February 11, 1988

Re: Revision No. 7  
Project Operations Plan  
SCP Site Remedial Investigation  
Carlstadt, New Jersey

The following revisions to the March 4, 1987 Project Operations Plan (POP) are based on our meeting of February 5, 1988.

## PROPOSED ADDITIONAL PIEZOMETER LOCATIONS SCP CARLSTADT

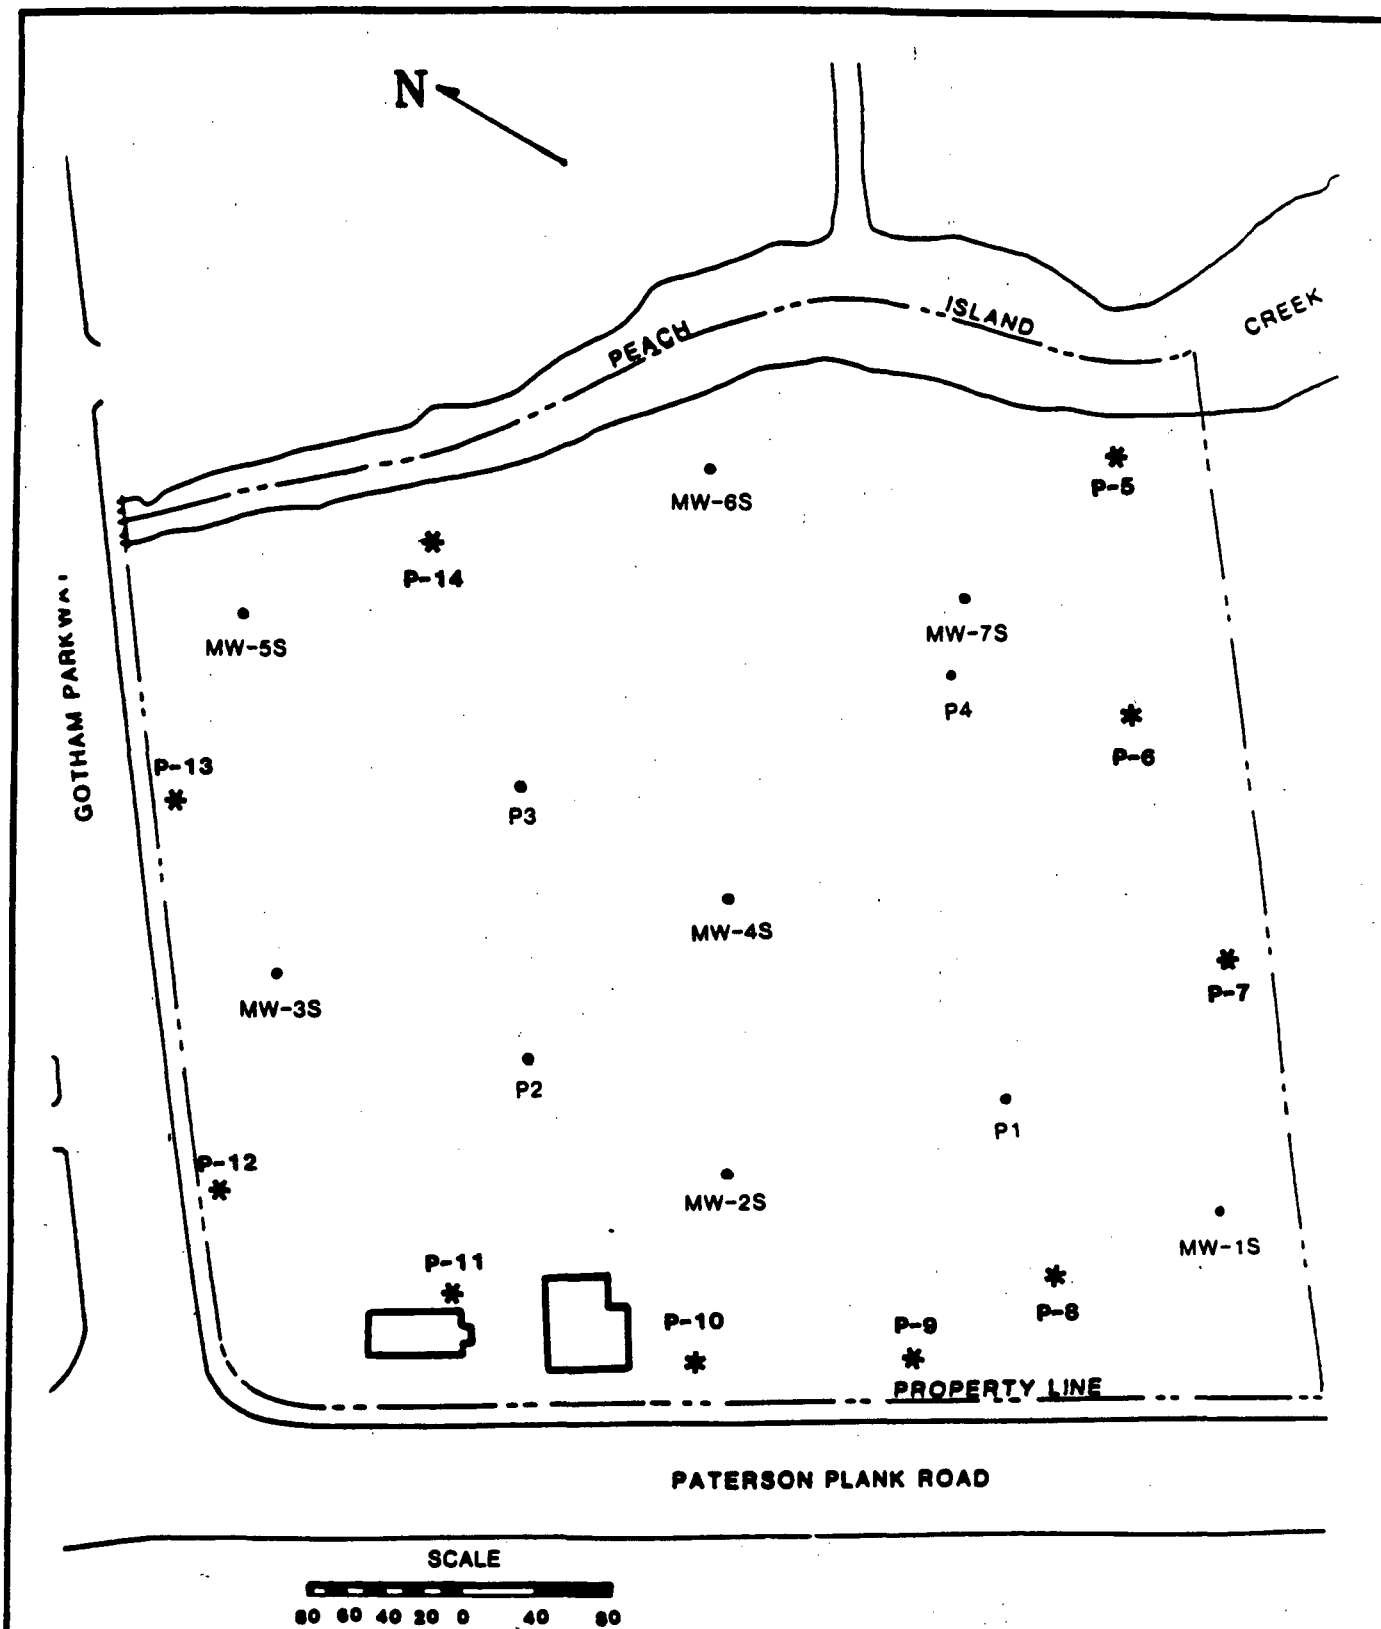
B. Section 7.7: Add Supplemental Piezometers in accordance with this section except as follows:

1. Paragraph 7.7.1, Objective: The objective of installing additional piezometers is to obtain supplemental water level data on the ground water flow regime of the upper saturated zone. The data will be used in conjunction with water level data from existing shallow wells and piezometers to provide a basis for the location of off-site wells in the shallow aquifer. Existing piezometric data from the shallow aquifer indicate that sewer line installation trenches adjacent to the site and buried mosquito control trenches within the site may be controlling, to some degree, ground water flow directions in the shallow aquifer. Several rounds of water level data will be collected from all site wells and piezometers (including the additional piezometers) and evaluated. Off-site well locations in the shallow aquifer will be based on these evaluations, in conjunction with discussions with the EPA. The additional piezometer locations are shown on Figure 7-7.

## PROPOSED SEISMIC LINE LOCATIONS SCP CARLSTADT

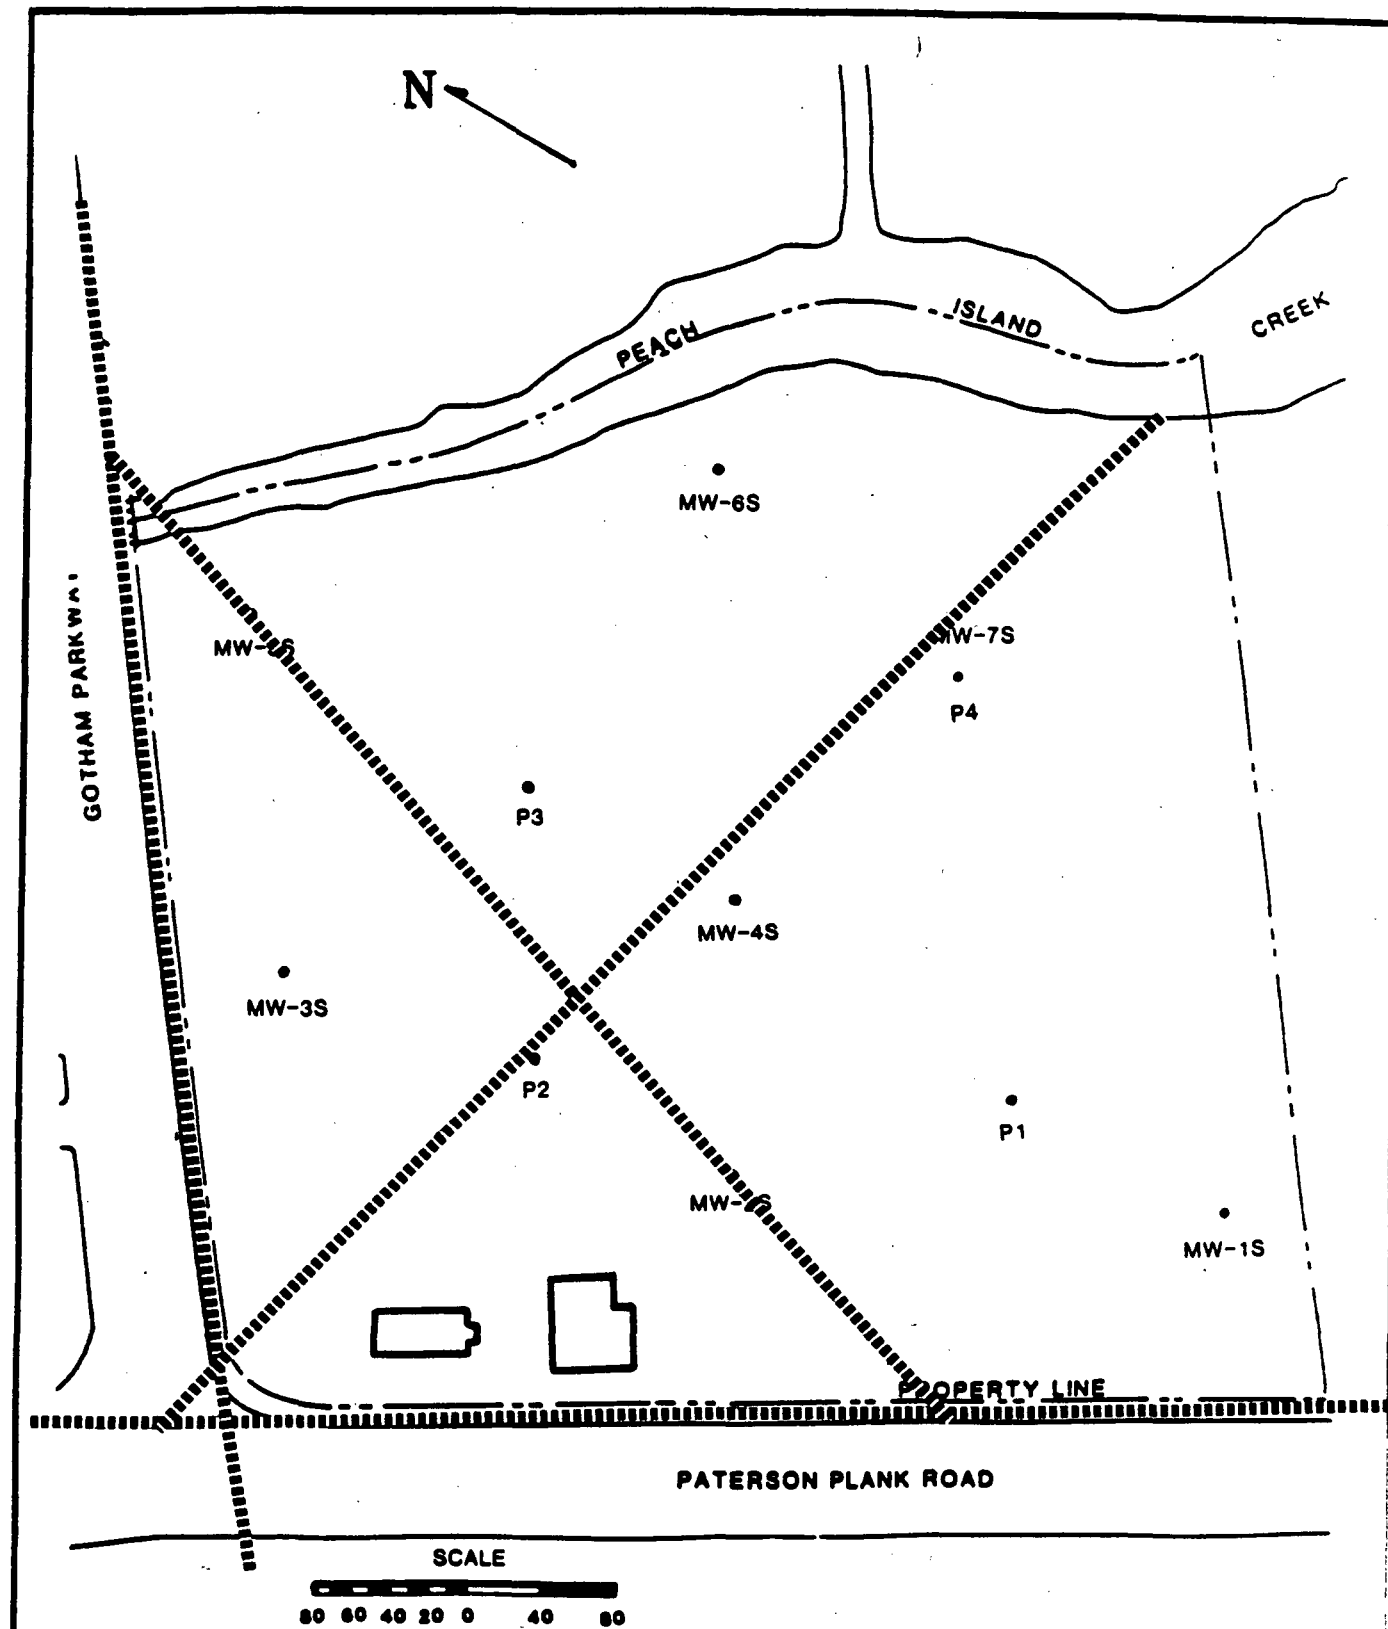
A. Section 7.6: Add Seismic Profiling in accordance with this section, except as follows:

2. Paragraph 7.6.5.3, Seismic Profiling: The profiling will be performed using seismic refraction techniques. Four profile lines will be deployed as shown on Figure 7-6. Geophones will be placed at regularly-spaced intervals along the profile lines and a 150-pound weight falling on a 2-foot square steel plate will be used as an energy source. Each profile line will be shot in both directions. Lines crossing the site will be tied into the existing deep borings.
